**City of Kingston**  
**Report to Heritage Properties Committee**  
**Report Number HP-24-012**

**To:** Chair and Members of the Heritage Properties Committee  
**From:** Jennifer Campbell, Commissioner, Community Services  
**Resource Staff:** Kevin Gibbs, Director, Heritage Services  
**Date of Meeting:** February 21, 2024  
**Subject:** Application for Heritage Permit  
**Address:** 47 Wellington Street (P18-386)  
**File Number:** File Number: P18-096-2023

An application for alteration under Section 42 of the *Ontario Heritage Act* (P18-096-2023) has been submitted to support a total of 17 condominium units for the entire property by building a rear yard, four-storey flat-roofed addition with an associated service elevator that will attach to the existing schoolhouse. This application was deemed complete on January 4, 2024. The *Ontario Heritage Act* provides a maximum of 90 days for Council to render a decision on an application to alter a heritage building under Section 42(4). This timeframe will expire on April 3, 2024.

Updated Renderings from Eye Level showing Reduced Height and Change in Colour of Elevator Overrun:

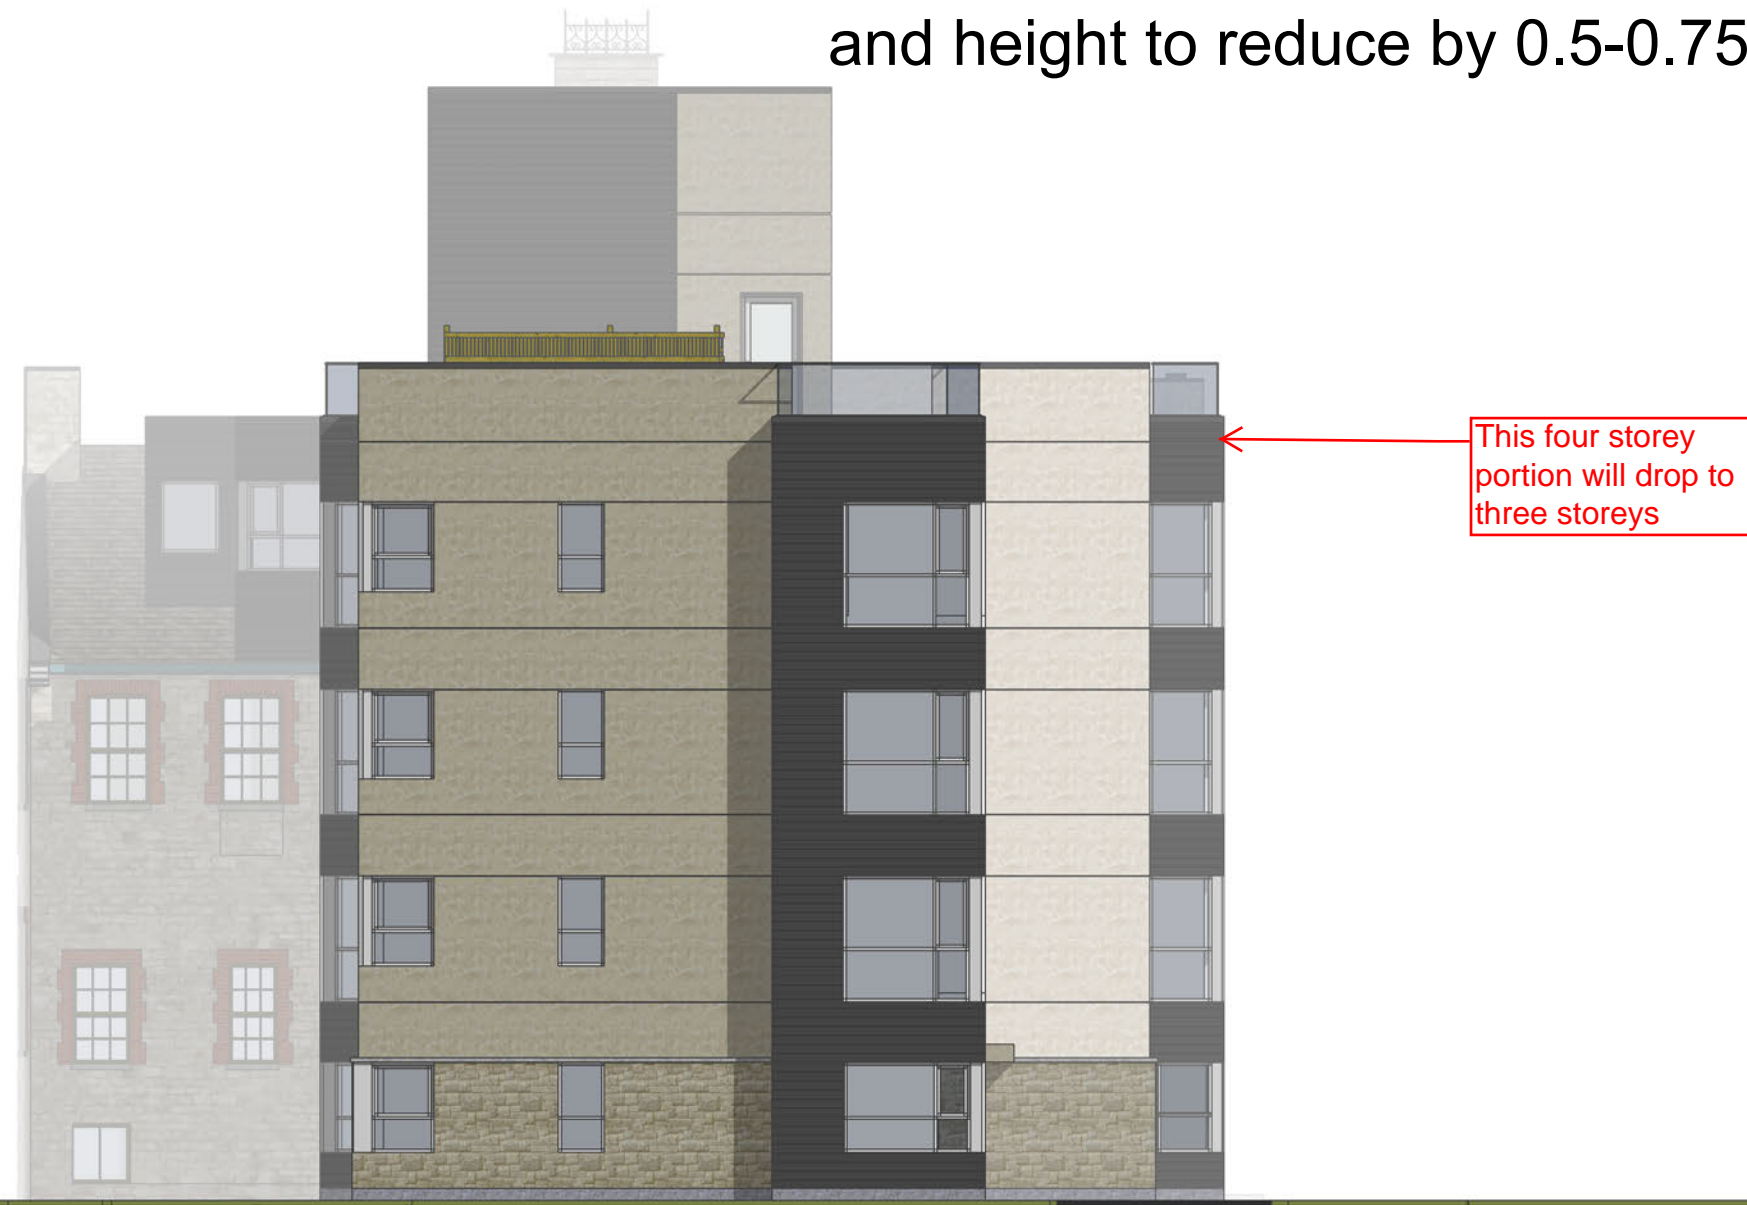
Elevator overrun colour to be more muted and height to reduce by 0.5-0.75 metres

Elevator overrun colour to be more muted and height to reduce by 0.5-0.75 metres

Special number British Whig, May 1895,  
coll. J. McKendry

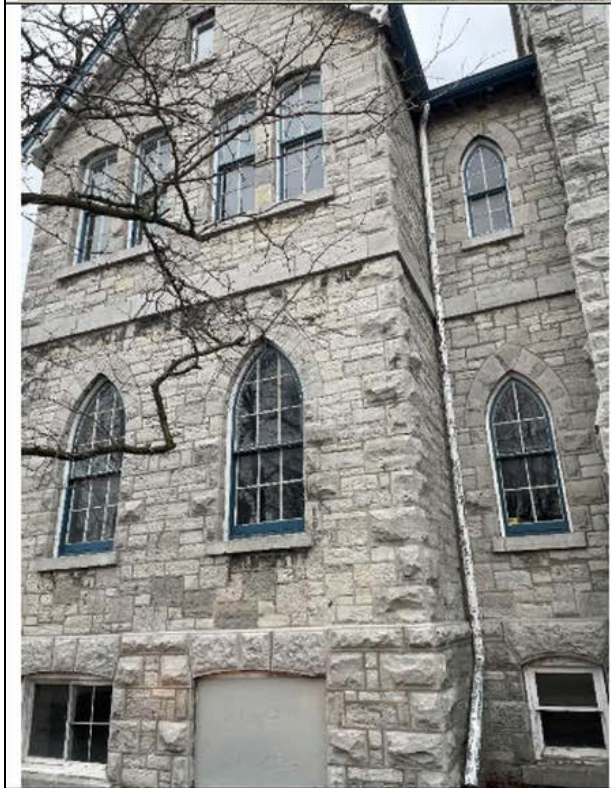
See the Hewett House of 1875 RMC, for a recently replaced metal fringe
